**RE: PART 8 - Construction of a Shared Pedestrian and Cyclist Facility
Between Coote's Lane and the N76 Ring Road, Kilkenny**

INTERIM CHIEF EXECUTIVE'S REPORT

**Proposed Coote's Lane to Ring Road
Active Travel Scheme**

13 Appendix E - Revised General Layout & Profile

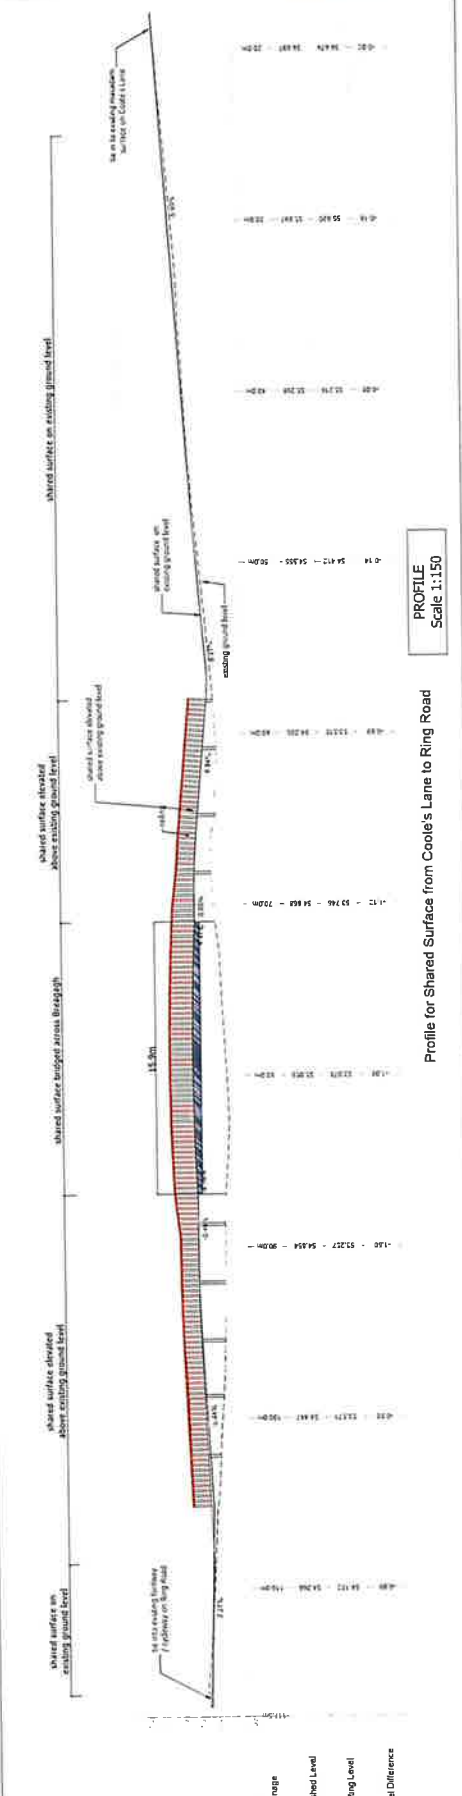
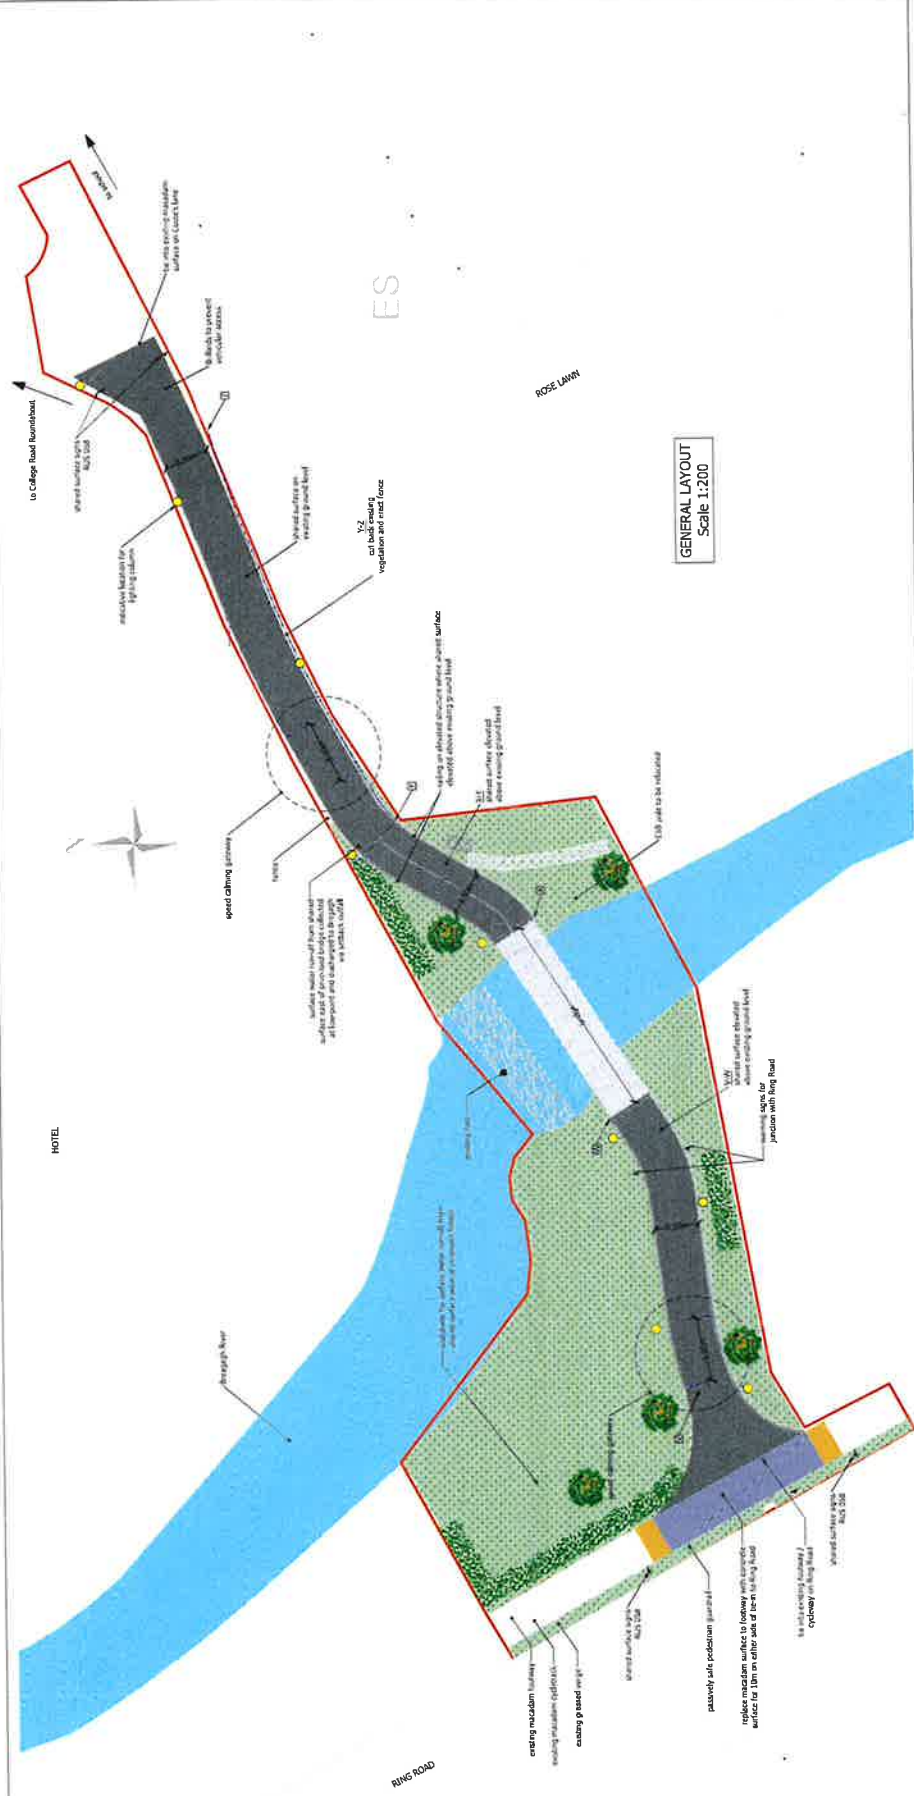
1. On the submitted engineering drawing Shared Surface From Coote's Lane To Ring Road general Layout And Profile No. 21079-C-DR-101 - PL1 it shows the shared surface macadam area with a slope of -6.99% to -9.27% coming from the Coote's land footpath direction and a slope of 3.29% from the N76 cycle/footpath direction with no regard to how surface water shall be contained and prevented from entering the Breagagh river during heavy rainfall.

The planned soakaway shown on drawing number 21079-C-DR-101 to the west of the River Breagagh should take runoff from the path only and not from the nearby ring road. The soakaway must be designed in accordance with CIRIA C753 The SuDS Manual (Sustainable Drainage System).

in 2021. The Department notes the inclusion of artificial lighting along the new pathway. Drawing Number 21079-C-DR-101 indicates that there will be dual aspect lighting at the bridge to illuminate the ford within the River Breagagh. Artificial lighting beside rivers can significantly alter the dynamics of aquatic insect populations and their predators and should be avoided. Therefore, the Department strongly advises against the use of dual aspect light designed to illuminate the ford in the river, which it considers will likely have negative impacts on biodiversity. The element of the project should be reconsidered.

1. On the submitted engineering drawing SHARED SURFACE FROM COOTE'S LANE TO RING ROADGENERAL LAYOUT AND PROFILE No. 21079-C-DR-101 - PL1 it shows the shared surface macadam area with a slope of -6.99% to -9.27% coming from the Coote’s land footpath direction and a slope of 3.29% from the N76 cycle/footpath direction with no regard to how surface water shall be contained and prevented from entering the Breaghagh river during heavy rainfall.

Drawing 21079-C-DR-101 has now been updated to reflect the responses to the submissions contained in this report.

Scheme lighting will be designed to minimise light-polluting effects while at the same time providing the minimum illumination required for the safe movement of all people using the proposed development. Dual aspect lighting will be omitted and cowls and covers added as required to minimise sky-glow and unnecessary overspill of light outside of the area required for safe use of the proposed development.

Tree and hedgerow planting has been moved to provide the required 10m buffer. Fencing has been omitted from the west bank of river. No wildflower planting is proposed.

- Cycle calming gateway moved closer to junction
- Yield markings removed.
- Tactile paving added to identify transition between shared area and segregated cycleway/footpath.
- Guardrail included along grass verge over extent of pedestrian/cycle junction
- Cycle / pedestrian junction widened to improve inter-visibility.
